August 16, 2019

Subject: Version 8 ENERGY STAR Computer Specification Draft 2 Comments

**Figure 1: Pass rates of desktops and integrated desktops in EPA dataset and the California MAEDbS by category.**

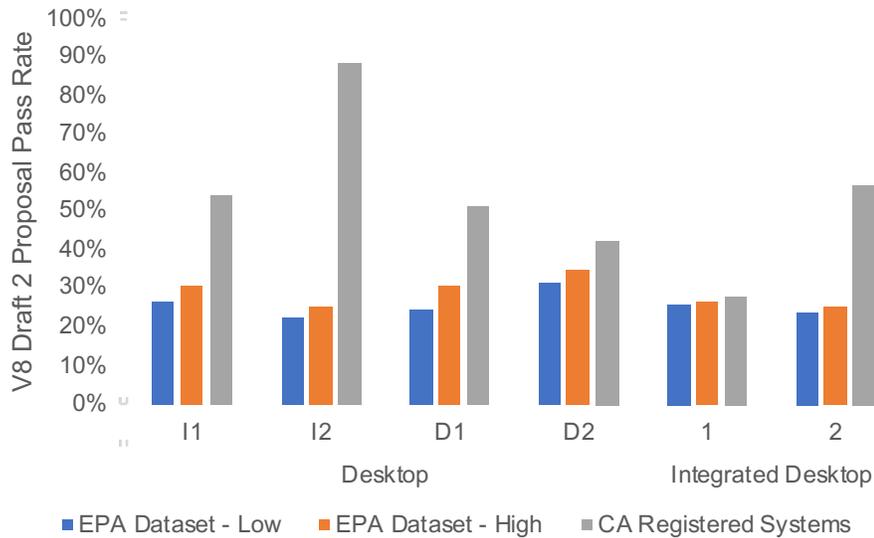
ENERGY STAR aims to target the top 25 percent of the market at the effective date of a new specification. However, the Draft 2 proposal would, for most desktop and integrated desktop categories, allow over 25 percent of the systems in the EPA’s data and analysis package to pass (Figure 1).<sup>1</sup> Systems in the data package are available on the market today, and some have been on the ENERGY STAR Qualified Products List for several years. However, the computer market has historically achieved continuous efficiency improvements, and today’s systems are unlikely to represent those available to consumers by the Version 8 proposed effective date in July 2020. To create a Version 8 specification that recognizes consumers’ best choice for efficient models, EPA should craft allowances and adders that result in pass rates in the 15 to 20 percent range, as suggested by the Natural Resources Defense Council in a previous comment.<sup>2</sup>

indicate that 51 percent of desktops, 49 percent of integrated desktops, and 94 percent of notebooks would pass the Draft 2 proposal (Figure 1). Although this dataset may not represent the current U.S. market, it does represent the likely shift in the market as additional states adopt the computers standard. Three other states have already adopted the standard: Vermont (effective in 2020), Colorado (effective in 2021), and Washington (effective in 2021).<sup>3</sup> These markets, which represent almost 20 percent of U.S. gross domestic product, are likely to drive the U.S. market toward more efficient models in the future.

1. **Reduce pass rates to anticipate U.S. market improvement and maintain relevance in states that have adopted the California Energy Commission (Energy Commission) standard** – Under EPA’s Draft 2 proposal, systems that have been on the market since as long ago as 2014 would qualify for ENERGY STAR. At a minimum, EPA should anticipate market improvements and set requirements that target a 25 percent pass rate of systems sold on or after the effective date in July 2020. However, CA IOU analysis of systems available for sale in California shows that 51 percent of desktops, 49 percent of integrated desktops, and 94 percent of notebooks would pass the Draft 2 proposal. If ENERGY STAR is to maintain relevance in markets that have adopted the Energy Commission standard and anticipate changes in the U.S. market as a result of greater market share of efficient products, pass rates must be reduced significantly.
